MEMORANDUM

To: Montgomery Township Zoning Board of Adjustment

Re: **The Bedens Brook Club**
Use Variance and Minor Site Plan
240 Rolling Hill Road
Block 31001, Lots 38 & 39
R-5 Single Family Residential Zone

Date: May 22, 2023

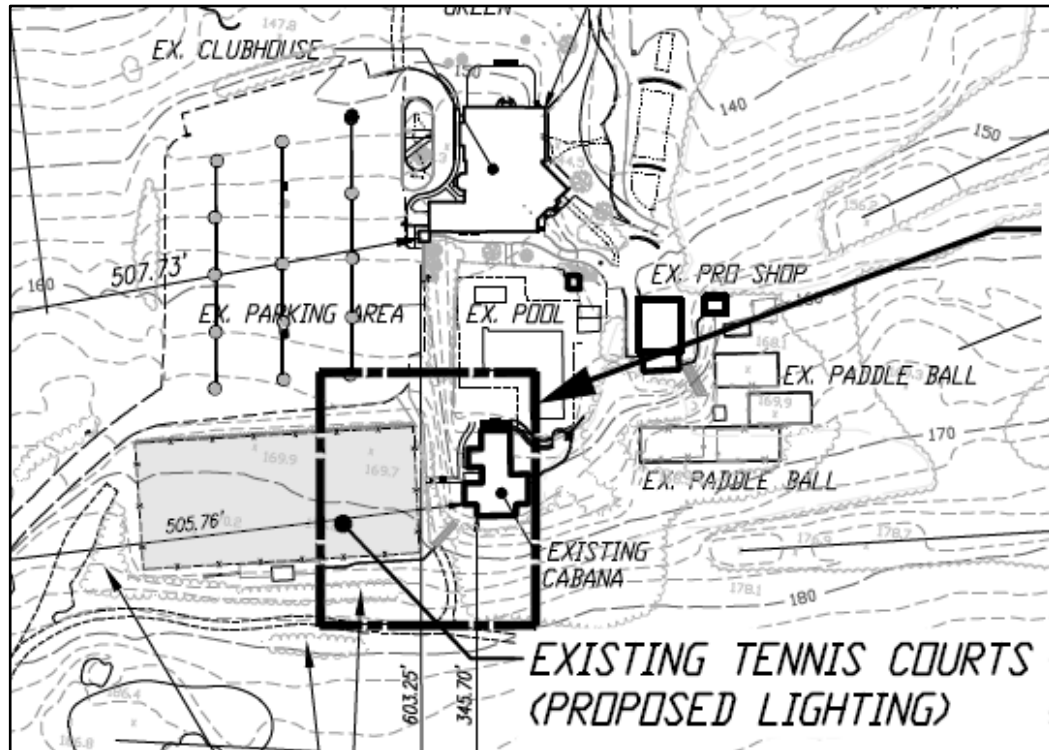
- 1.3 Existing Site Conditions – Project Area:** The project area consists of a relatively minor portion of the site. The following image, provided by the applicant as part of the overall site plan on Sheet 2, indicates the location of the tennis courts and proposed lighting. The tennis courts are south of the parking area, pool and clubhouse. The two (2) subject courts are part of a larger row of five (5) courts surrounded by an existing fence. To the south, west and north, the courts are surrounded by trees. Beyond the rows of trees to the south and west, which are where the closest adjacent properties are located, are two (2) golf holes, beyond which are wider rows of trees, beyond which are single-family homes. The distance of the proposed lights to the five (5) closest residential properties range between 332 feet to the south to 506 feet to the northwest and 749 feet to the southeast.
